Requests for Information (RFI)

Structured Cabling RFP 2025-02

Form 470-250006845

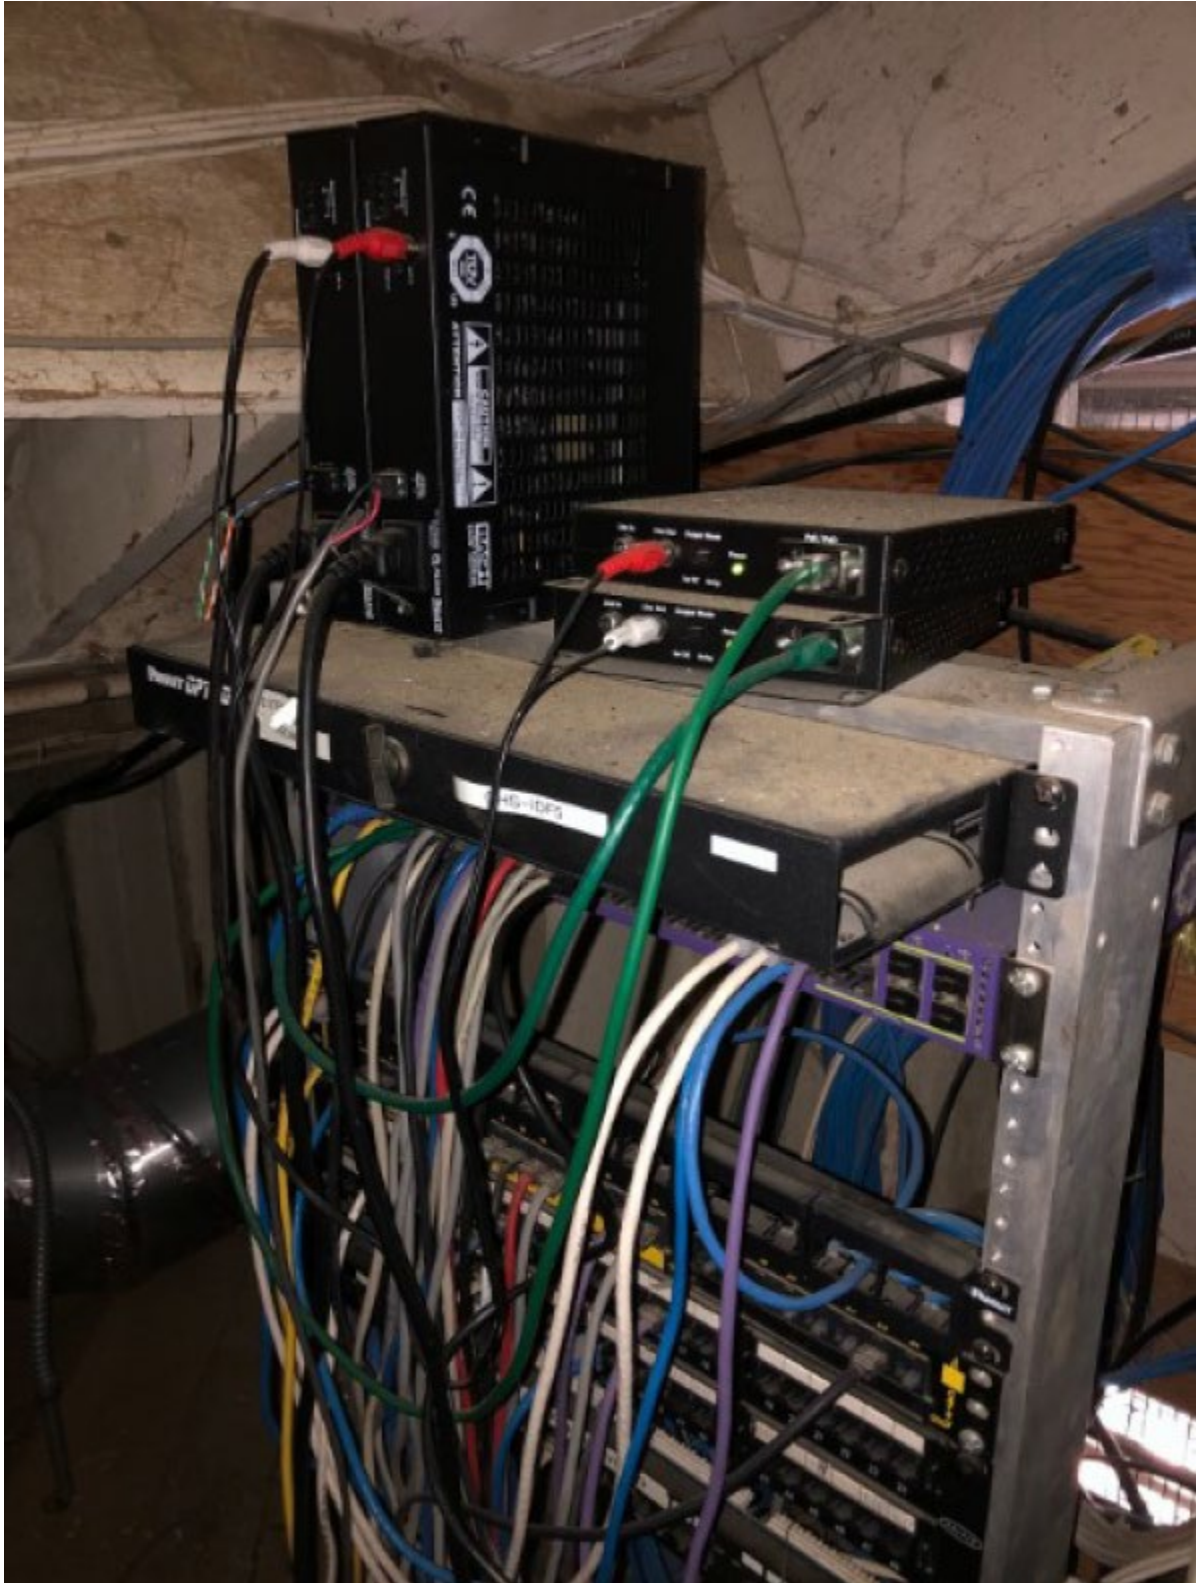
7. IDF 5 was not accessible during the site walk and this IDF needs a lift to access. Can we provide a picture of the IDF?

Answer: Yes – see picture below.
